GALLOWAY RESPONSE

CALAMAR 55+ AT STERLING HILLS - SITE PLAN

LOT 1, BLOCK 1, STERLING HILLS SUBDIVISION FILING NO. 14

COVER SHEET

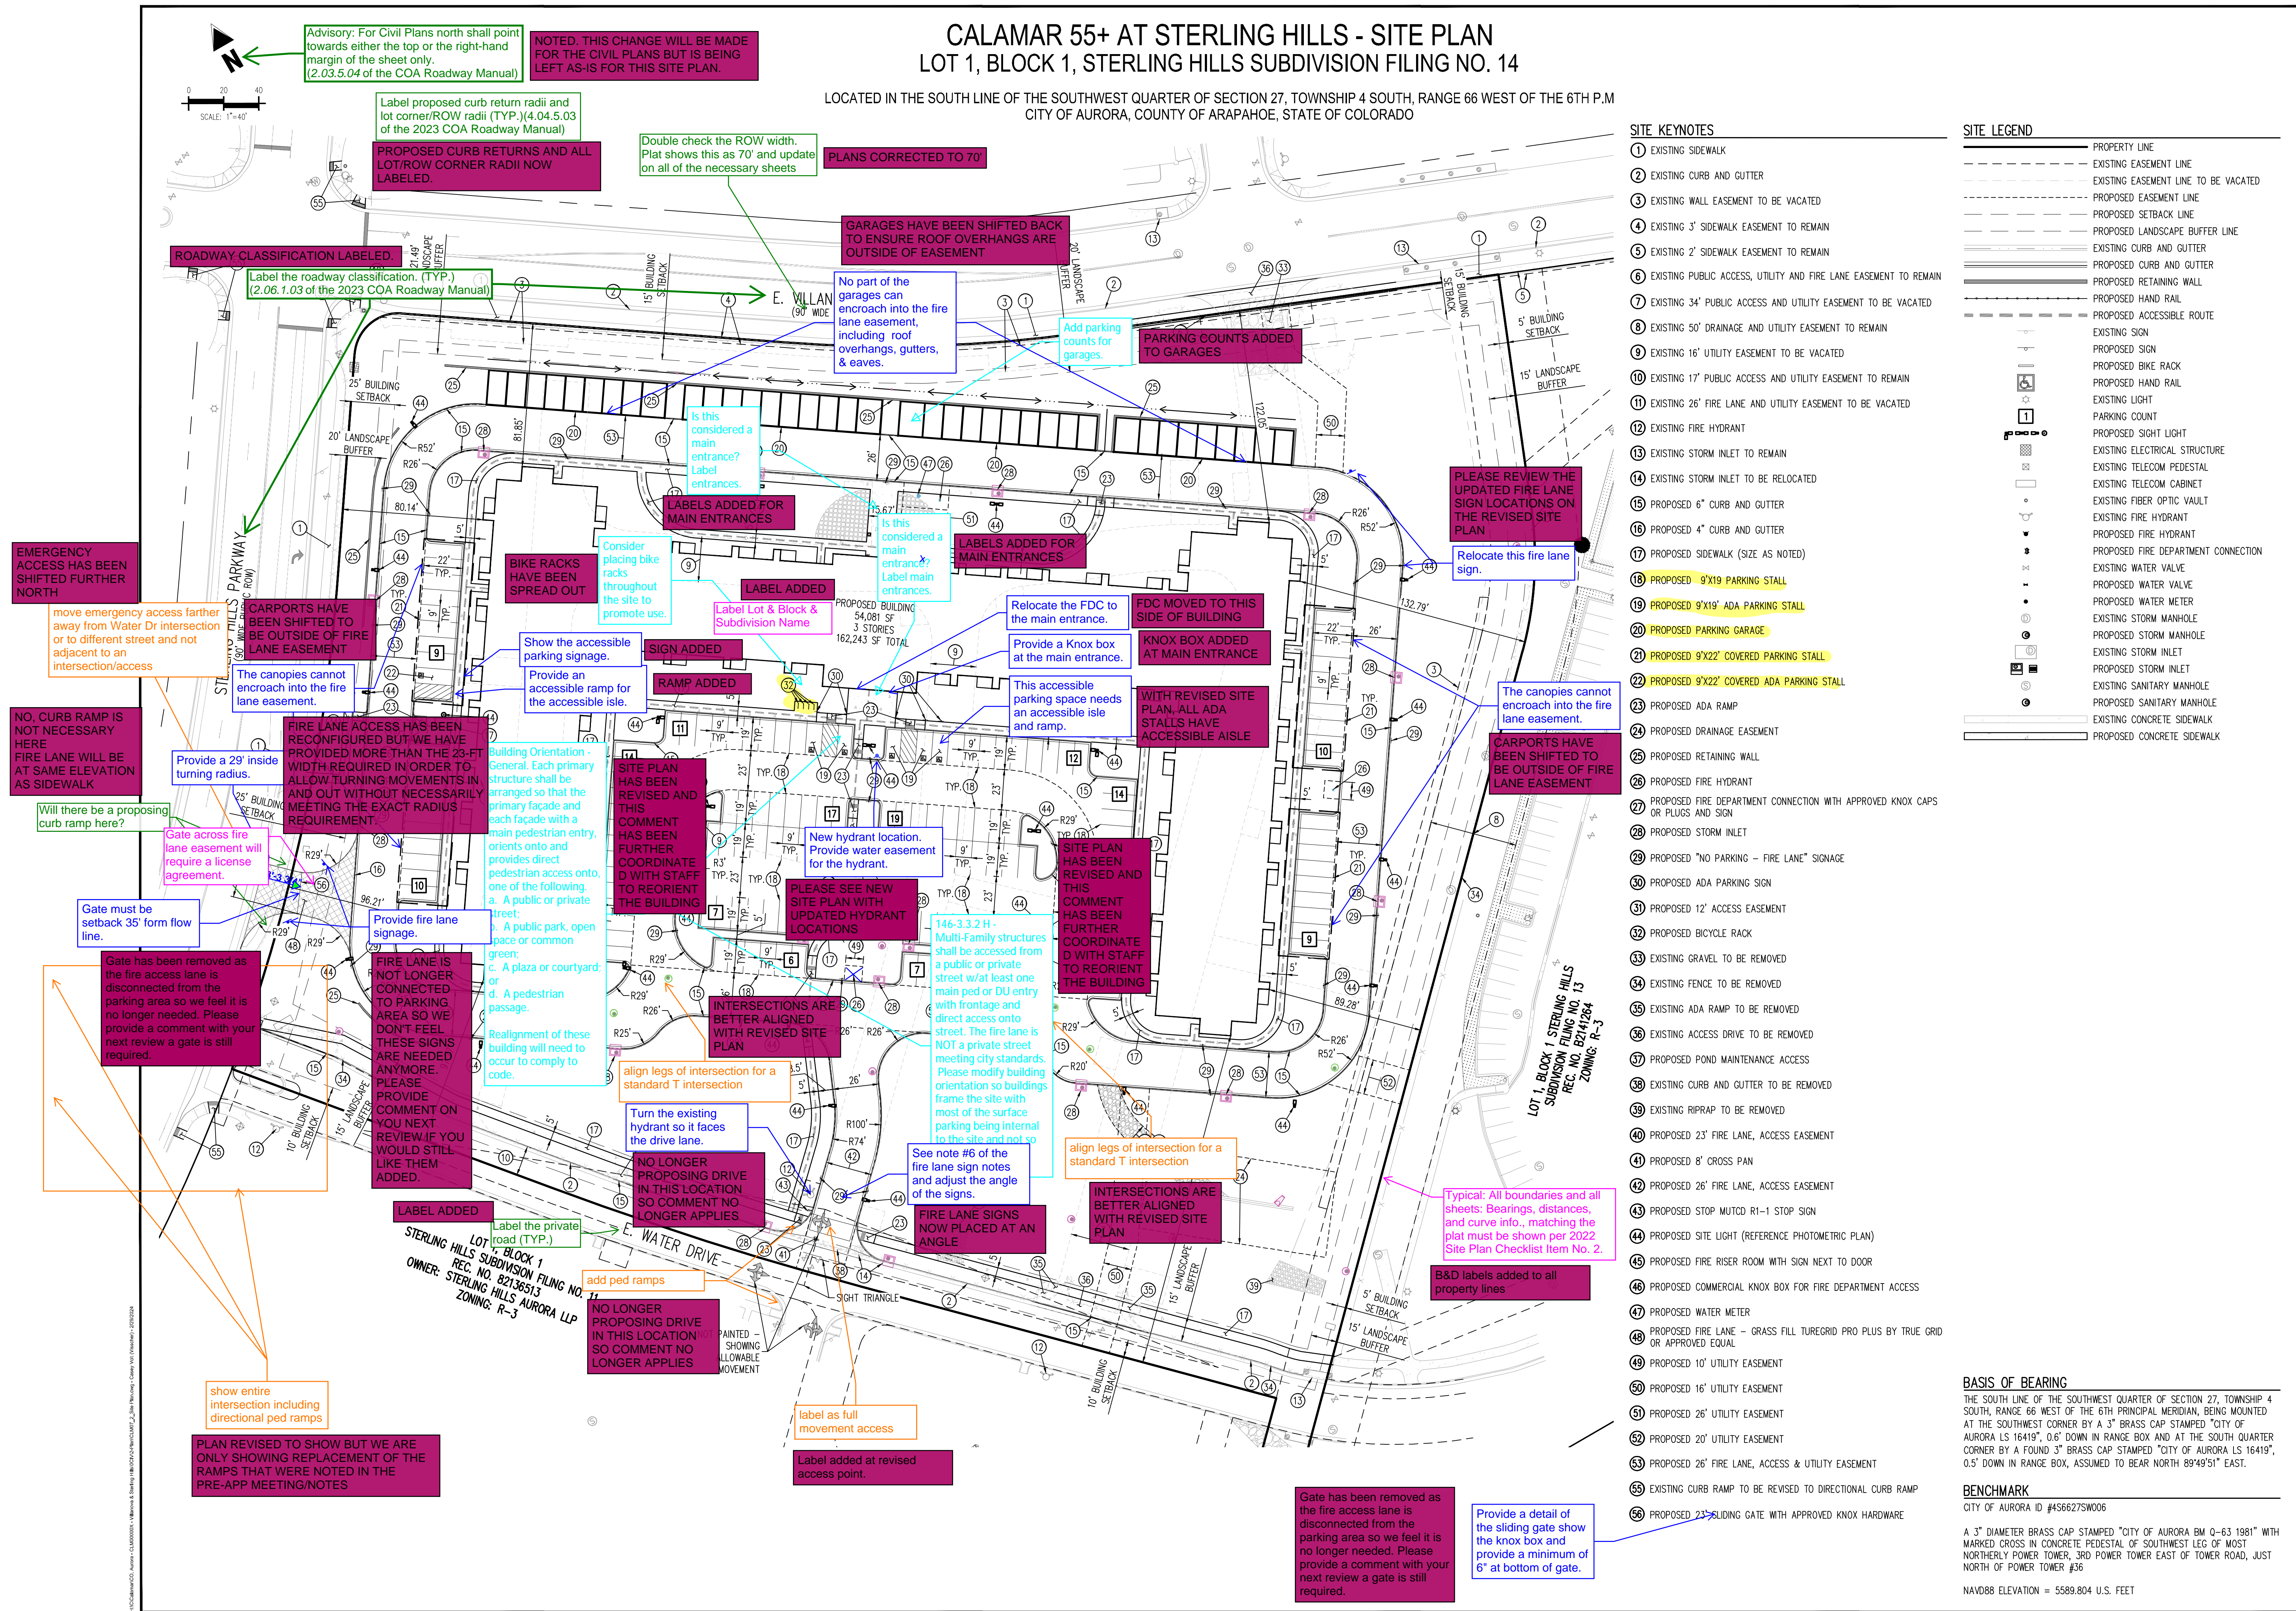
List garages and canopies separately.

Please include the major east/west roadway

The site plan will not be approved until the Preliminary Drainage Report is approved.

Provide a completed implementation table.

Please use "X of Y" on the sheet counts. i.e. 1 of 17.

Remove NFC stamp (TYP.)

Add subarea

The garage spaces are not shown on any sheets. Clarify.

ADDED TO TABLE.

WATER DRIVE LABEL ADDED TO PLAN

NOTED. PDR HAS BEEN RESUBMITTED CONCURRENTLY WITH THIS SUBMITTAL.

ADDED TO COVER SHEET.

ADDED TO ALL SHEETS.

REMOVED

ADDED.

THESE SPACES NOW HAVE AN ADA SYMBOL SHOWN SO THEY ARE MORE CLEAR.

LANDSCAPE PLAN

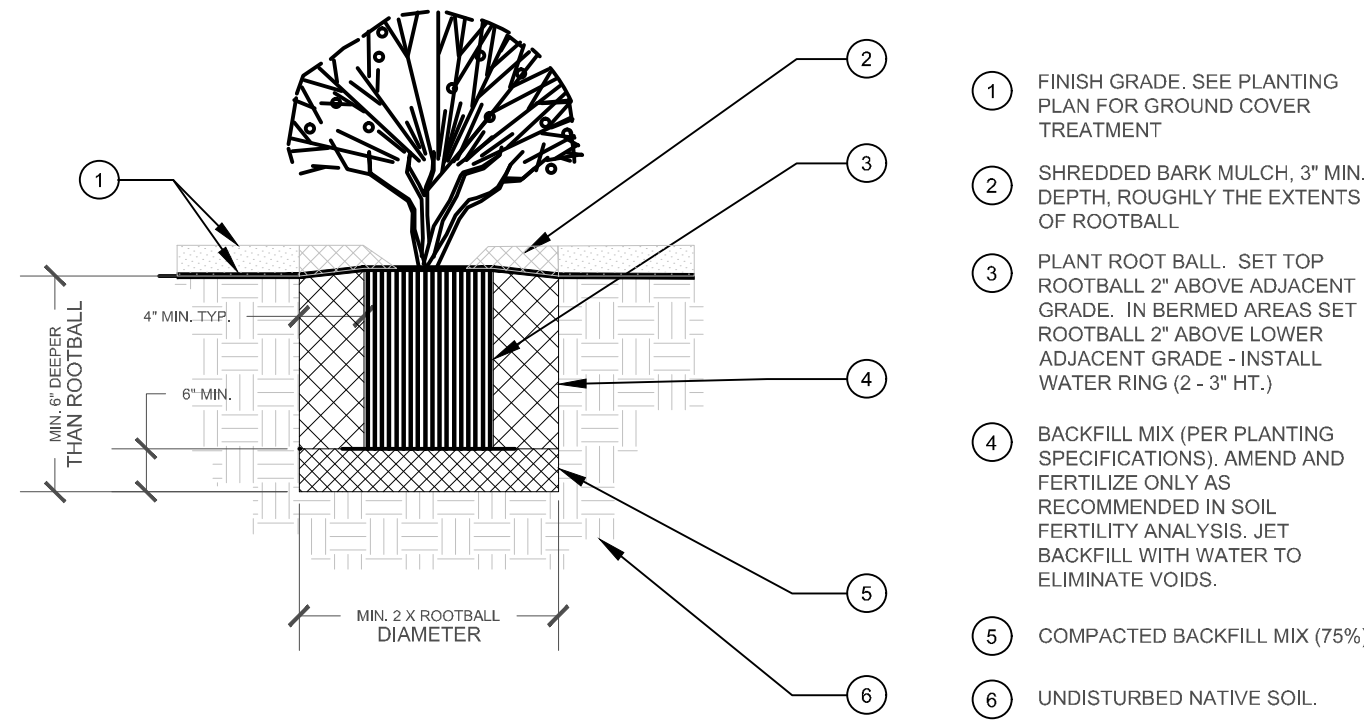
Show the extents of the entire site including the property boundary.

numerous mature plant heights within sight triangles exceed COA 4.04.2.10 requirements. Verify ALL mature plant heights within ALL sight triangles meet COA 4.04.2.10 requirements

It appears as if there are not street trees being provided in the curbside landscape due to the presence of utilities other than the three existing. Provide the required street trees along the back of walk and not placed all in one location as currently provided. These trees can be used to satisfy the street frontage buffer requirement.

Accommodate the emergency 2nd point of access.

add sight triangle per COA TE-13

Because the street trees are not being provided in the curbside area due to the existing utility, locate them along the back of walk spaced 40'. Evergreen trees can not count as street trees.

Show the property line as a traditional line type. A long dash and two short dashes.

Ensure all trees are 8' from the utility or 5' from the utility easement.

The plant schedule font is too small. Enlarge and place on another sheet.

Show meter pits and all fire hydrants on landscape plan.
PROVIDED AS NOTED.

This should be a deciduous canopy tree per the UDO.
REVISED.

Label the fire hydrants and show the hydrant symbol in the legend.
Labeled & INCLUDED IN LEGEND

The larger islands require 12 shrubs.
REVISED.

Nice shrub, but does not perform well here in Aurora.
NOTED. THIS SHRUB HAS BEEN REMOVED FROM THE PLANT PALETTE.

Space the buffer trees out along the non-street buffer.
REVISED AS NOTED.

REVISED. SITE EXTENTS ARE SHOWN.

NOTED & REVISED.

REVISED. SITE EXTENTS ARE SHOWN.

2nd POINT OF EMERGENCY ACCESS IS PROVIDED ALONG STERLING HILLS.

SITE TRIANGLES HAVE BEEN ADDED.

REVISED AS NOTED.

REVISED AS NOTED.

ENLARGED ON NEW SHEET.

LANDSCAPE NOTES & DETAILS

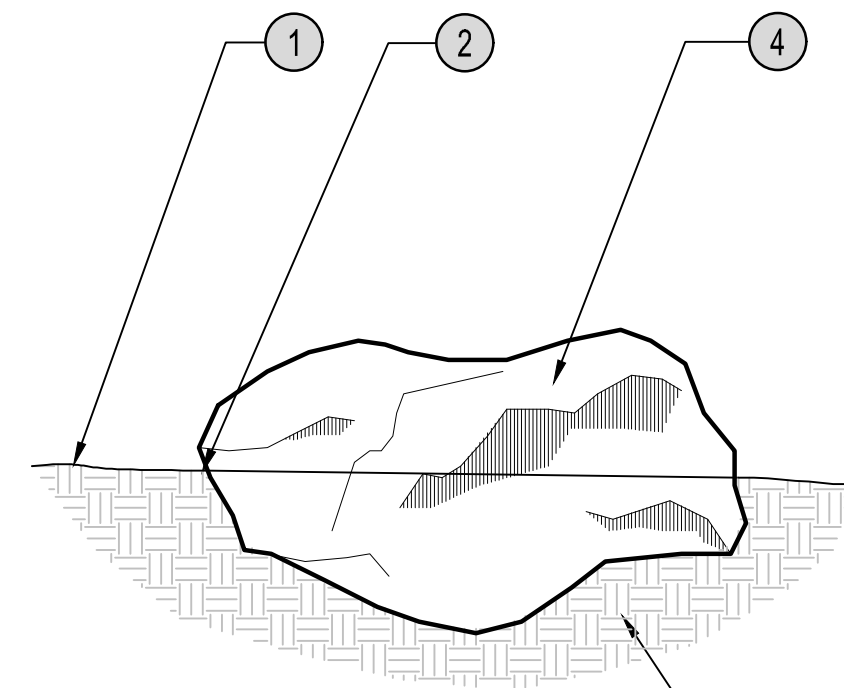
Provide a landscape table documenting the required detention pond landscaping. Refer to the pre-application review letter.

Is there a monument sign being proposed? If so, provide that on the plan as well as a detail

Provide a detail of the proposed retaining walls. Material, color etc.

PROVIDED.

REFERENCE GRADING PLAN.

Project No: CLM000007
Drawn By: MNS
Checked By: CMV
Date: 02/28/2024
PHOTOMETRIC PLAN

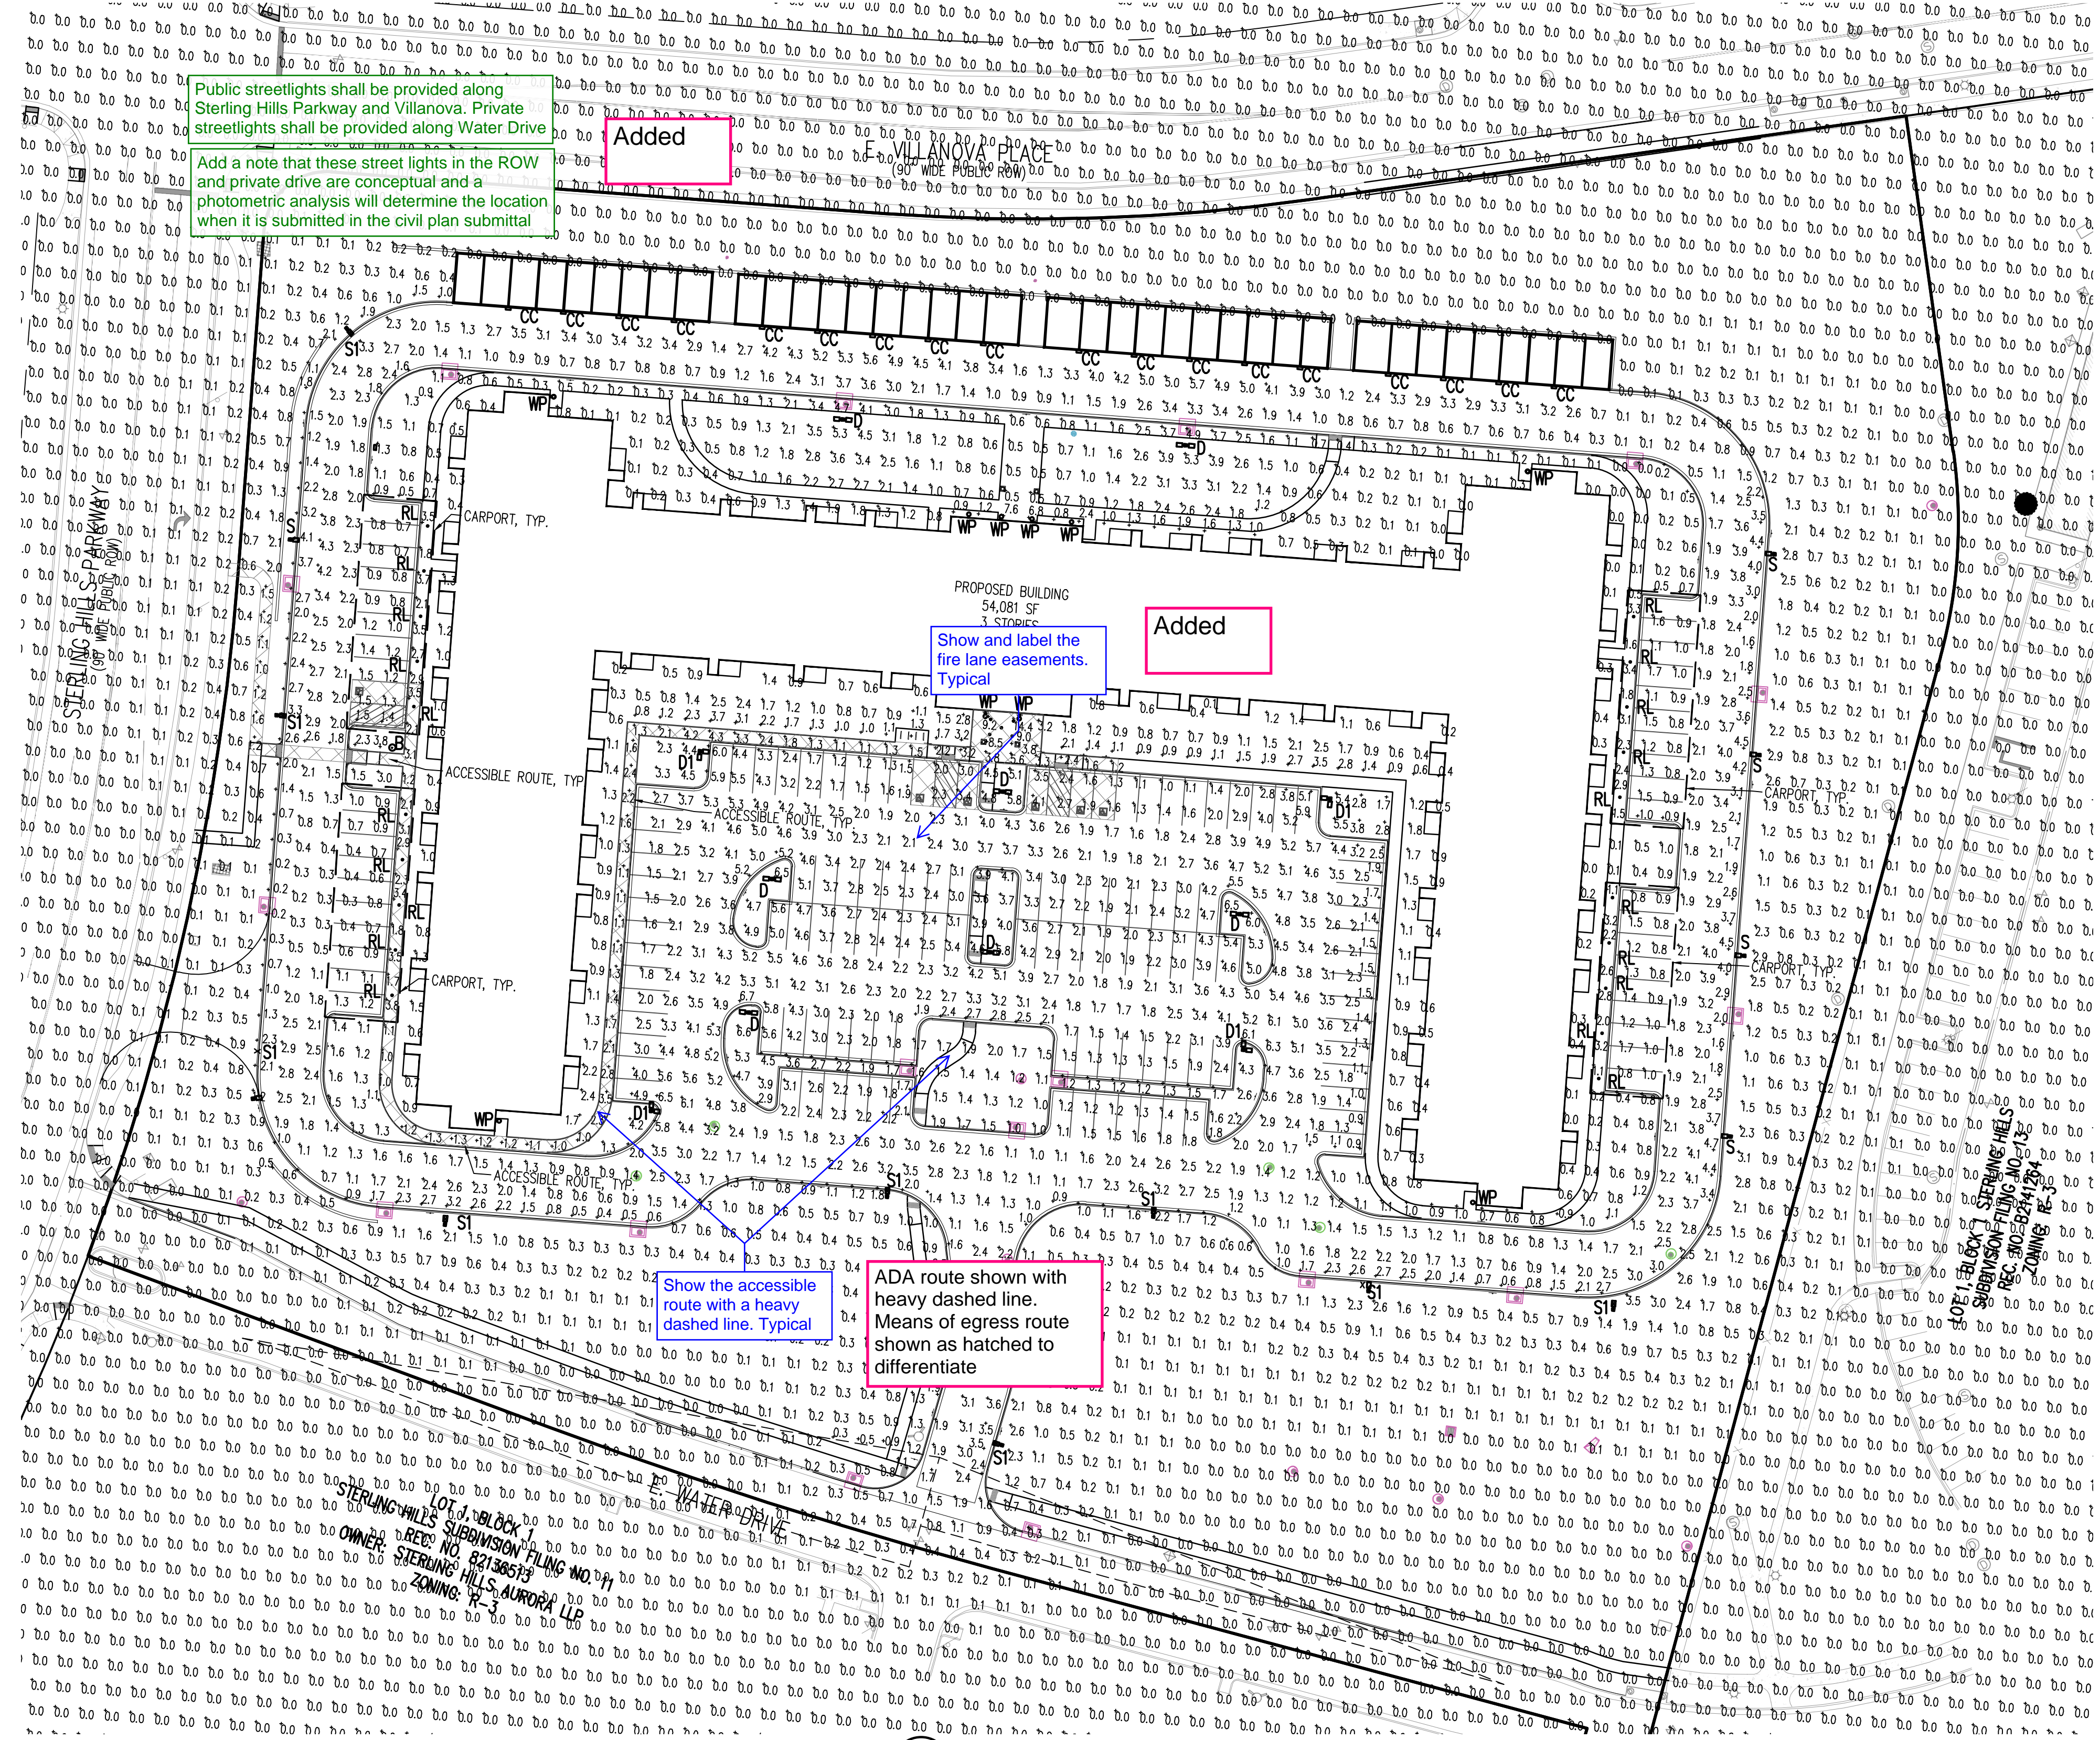
Please move photometric sheets to the end of the site plan set. These should be after the elevations.

For each street, identify the following information as part of the site plan submittal in conformance with Section 2.12.0.1 of the Roadway Manual:

This information (if its not already shown) can be added to the street sections provided if desired.

3 NORTH ELEVATION 2 - PRIMARY BUILDING FACE
SCALE: 3/32" = 1'-0"

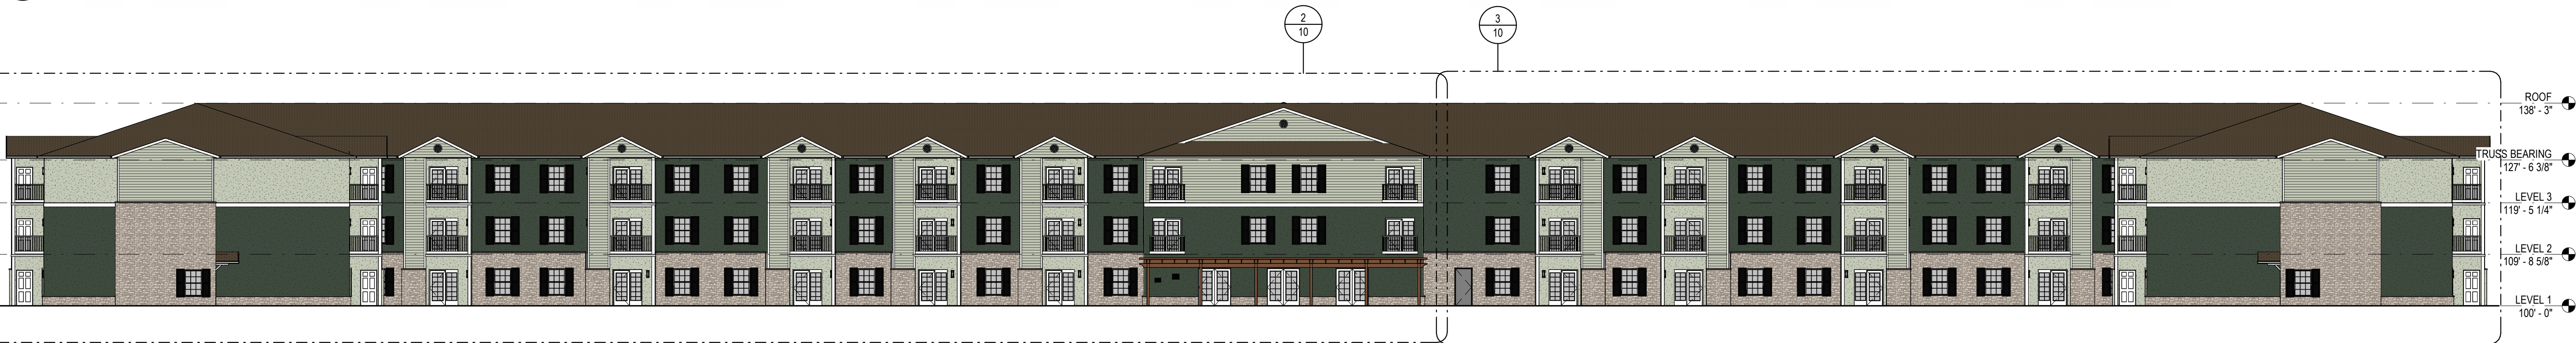
Please refer to section 146-4.8.5 for massing guidance on all elevations; Contact the Case Planner with any questions.

Please add building lengths for all elevations and add to data table on cover sheet as well.

Please dimension patios/decks with next submittal. Add to data block on coversheet as well.

Please show and label the FDC, Knox box & Fire Riser Room Door. Typical

REVISED

BALCONY DIMENSIONS
ADDED TO NOTES ON
SHEET 10 OF 21.

REVISED
